STATE OF HAWAII
DEPARTMENT OF TRANSPORTATION
HIGHWAYS DIVISION

ROADWAY DETAILS

KAHEKILI HIGHWAY WIDENING
Likelike Hwy. to Vicinity of Haiku Road
F.A. PROJECT NO. NH-083-1(26)

ROADWAY DETAILS	
KAHEKILI HIGHWAY WIDENING Likelike Hwy. to Vicinity of Haiku Road F.A. PROJECT NO. NH-083-1(26) SCALE: AS NOTED DATE: APRIL 1994 SHEET No. T5 OF T13 SHEETS AS-BUILT ADD. 5

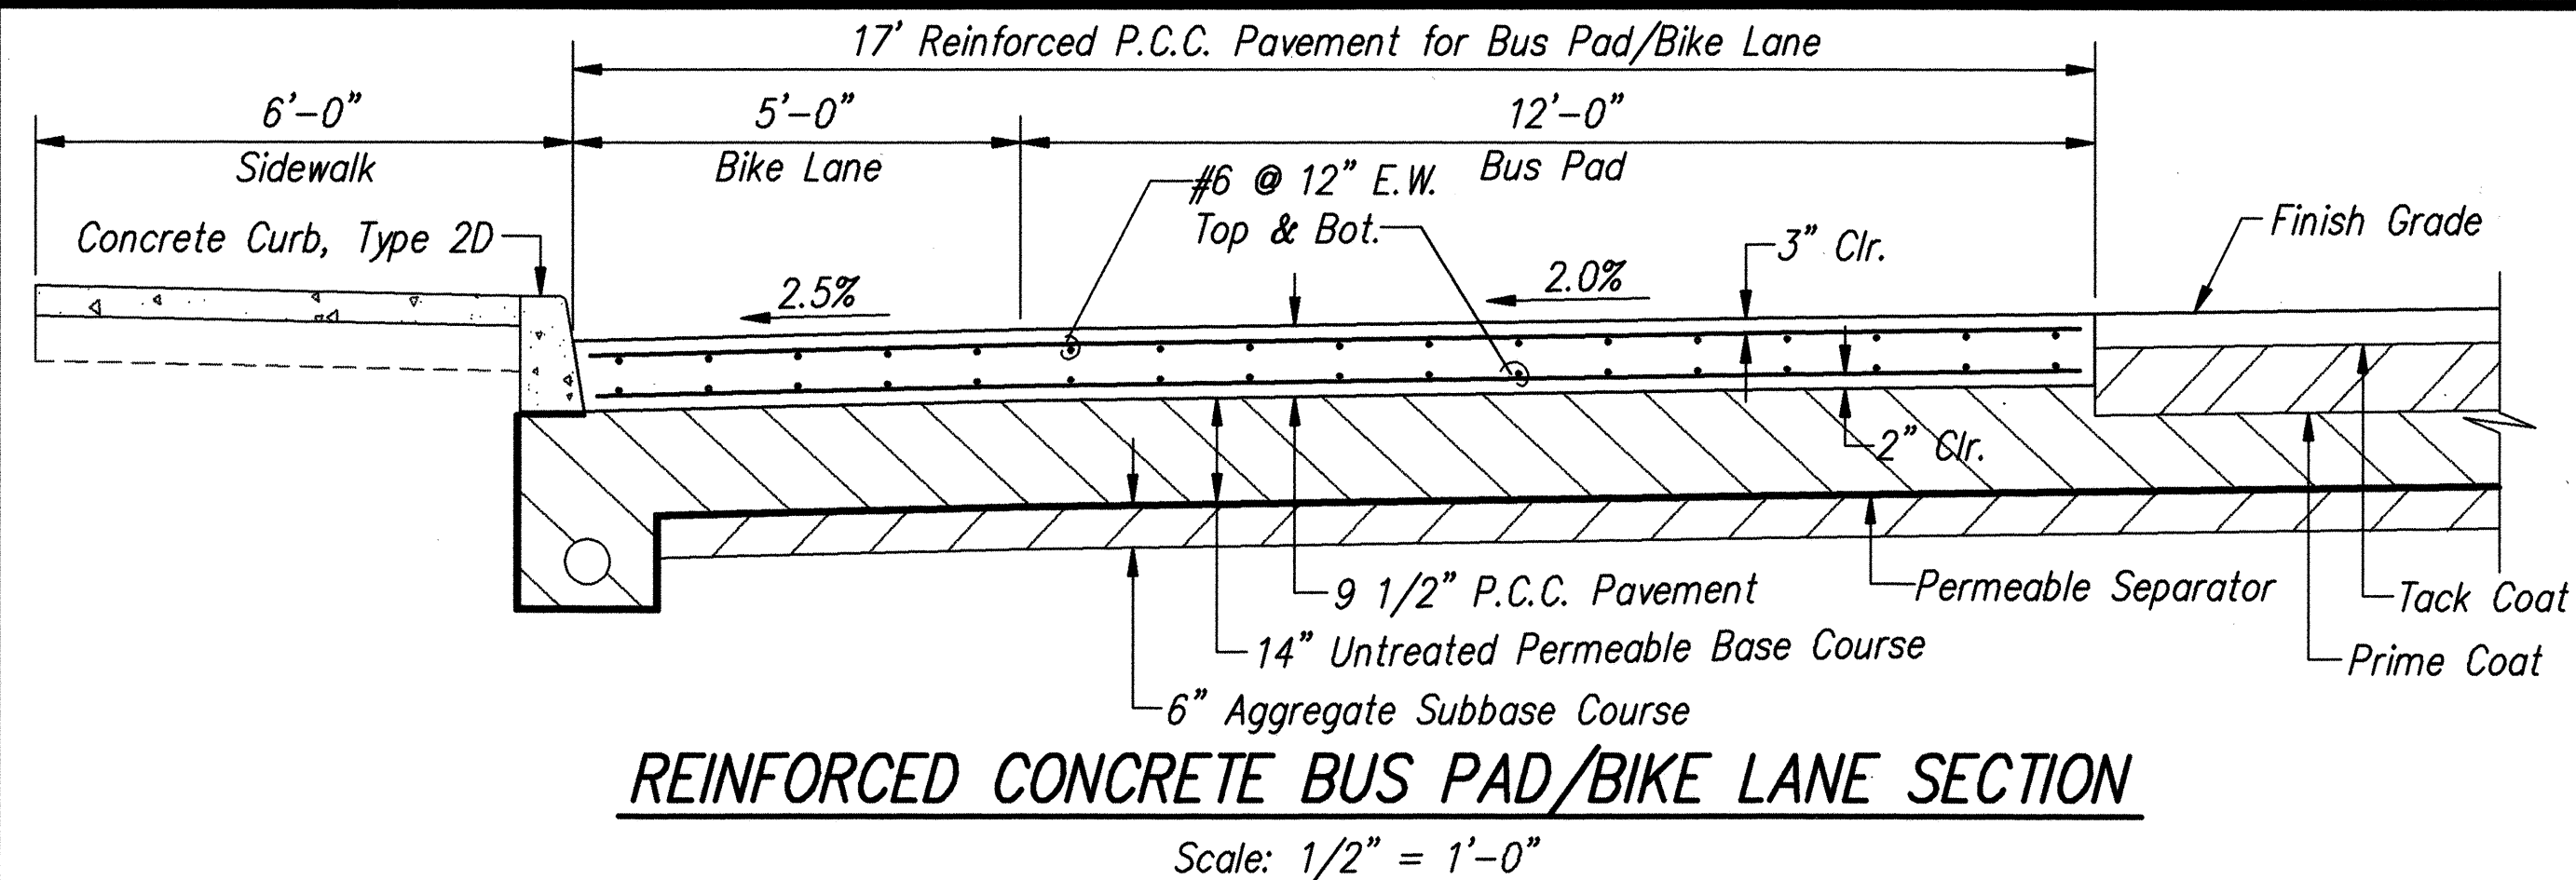
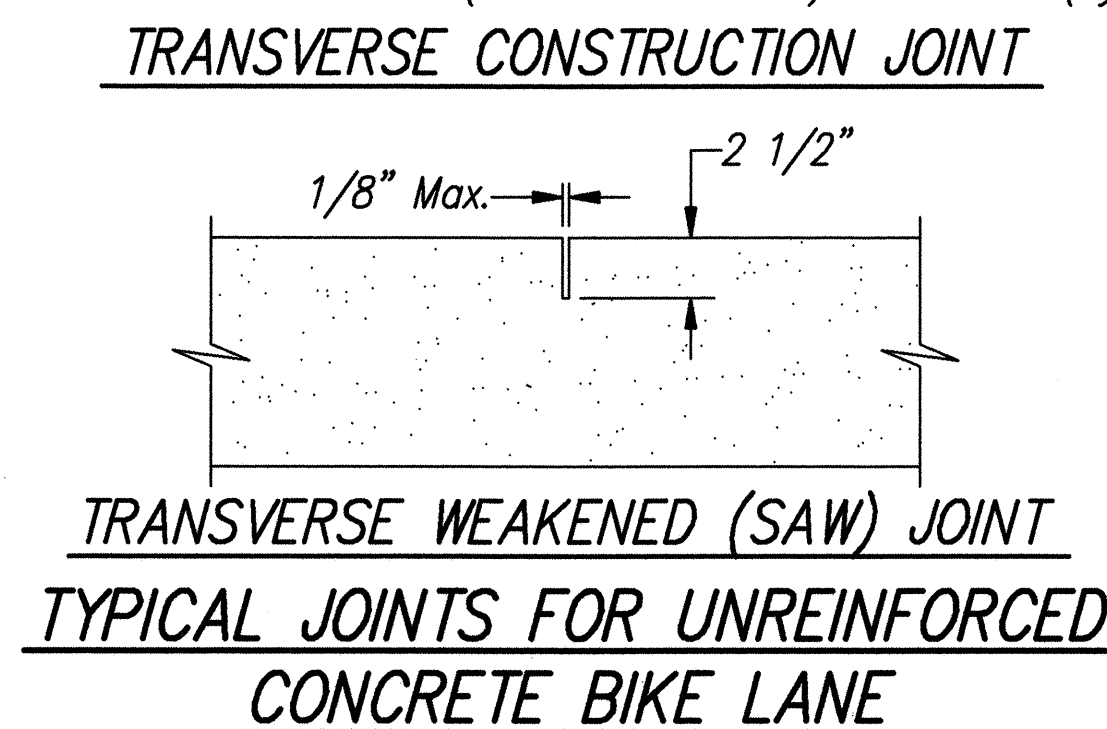
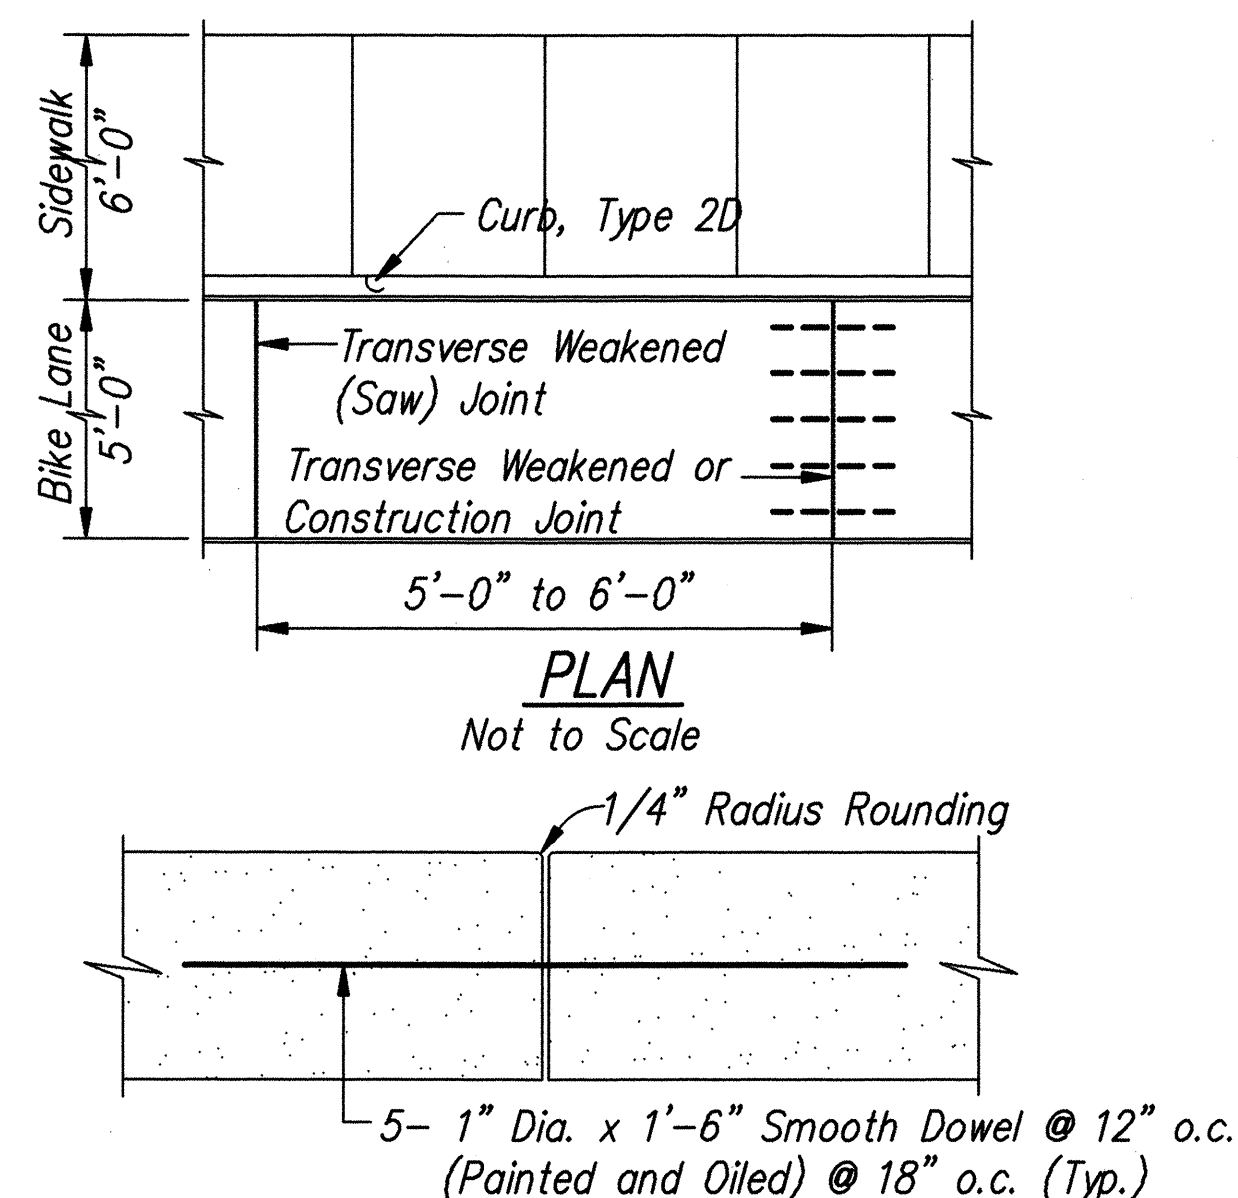
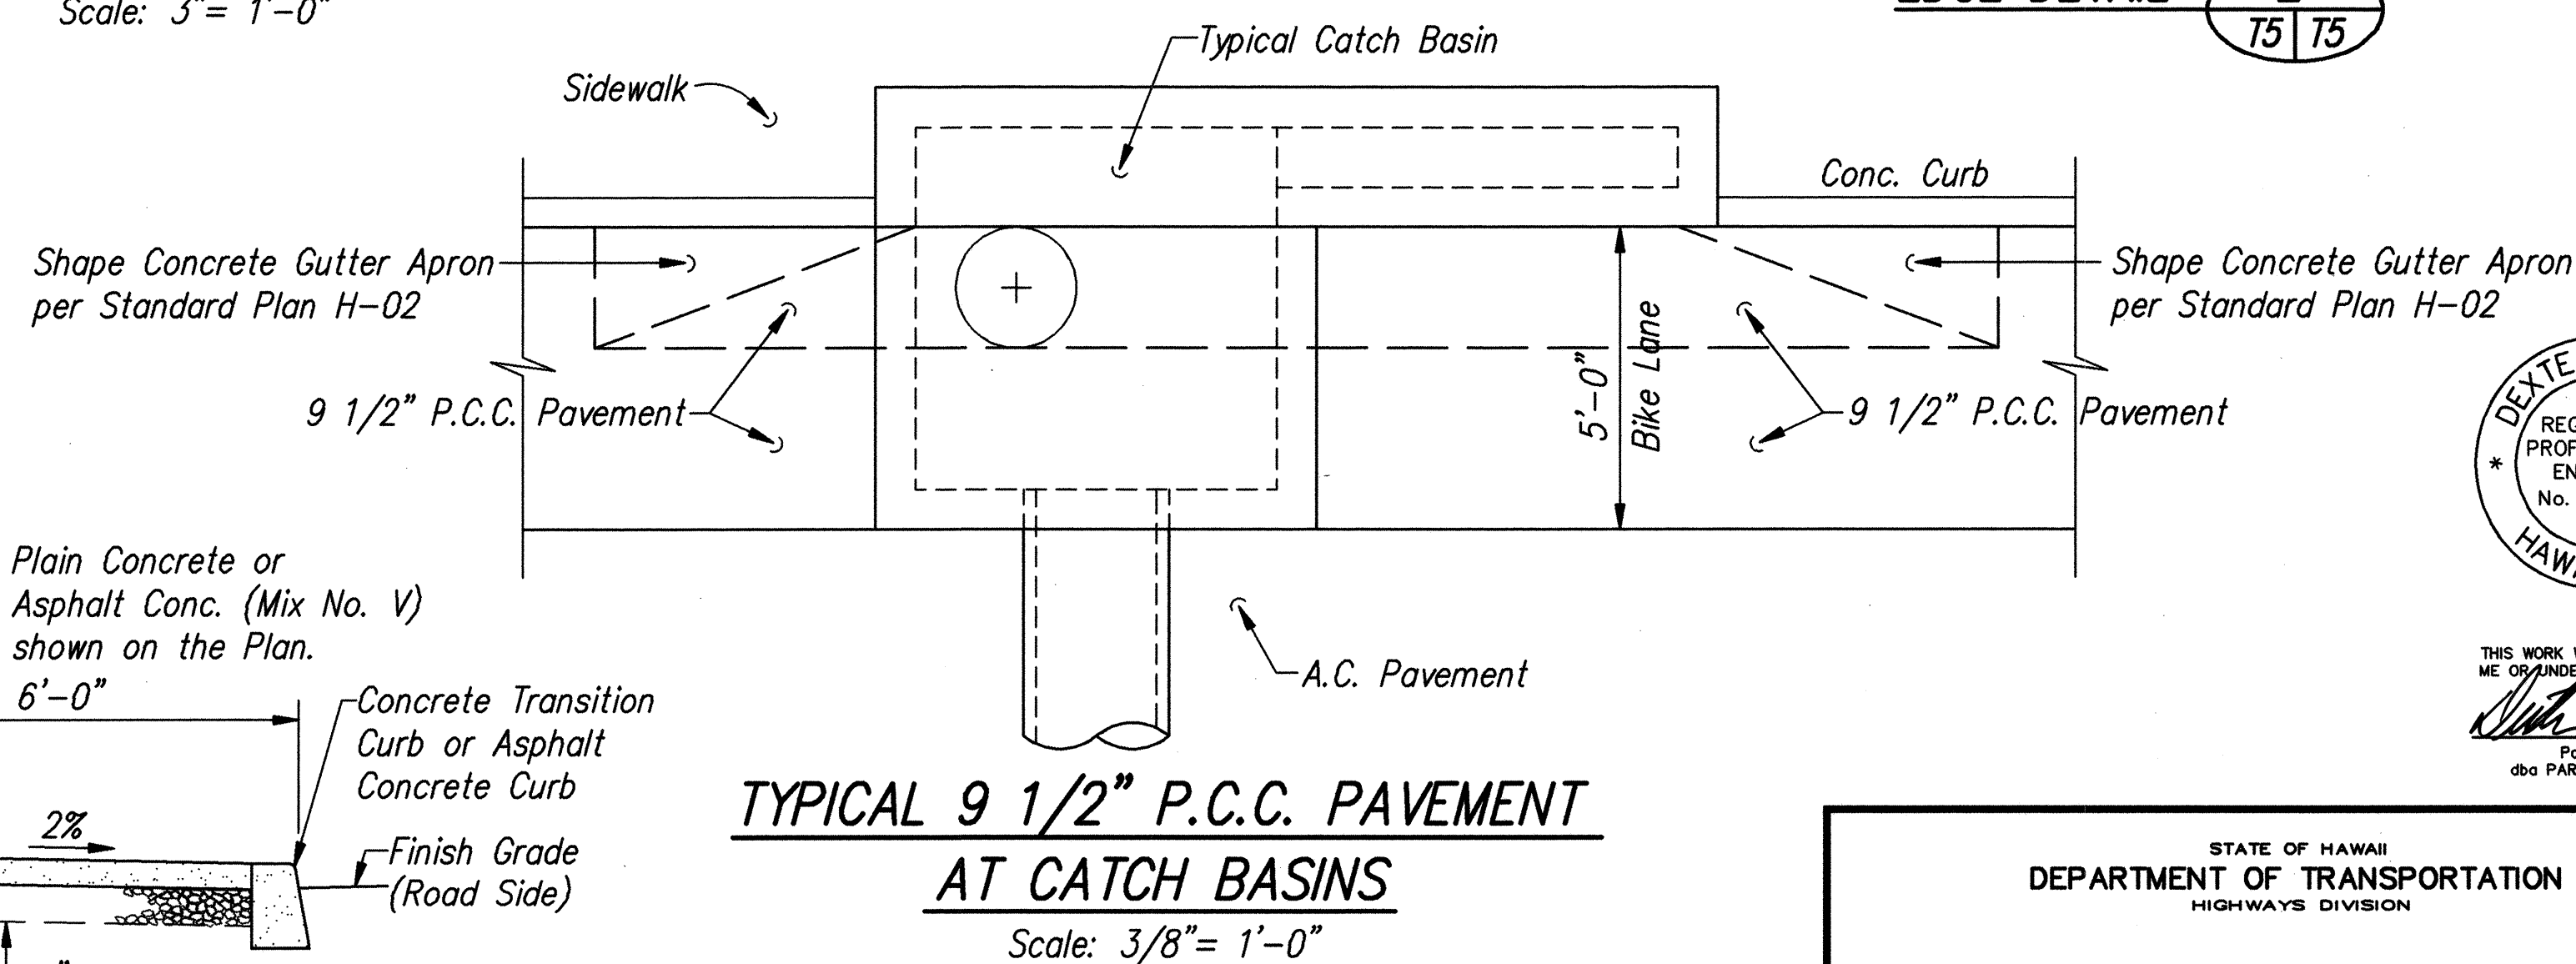
DATE	REVISION
6/07/94	REVISED REINFORCED CONCRETE BUSPAD/BIKE LANE DETAILS AND NOTES.
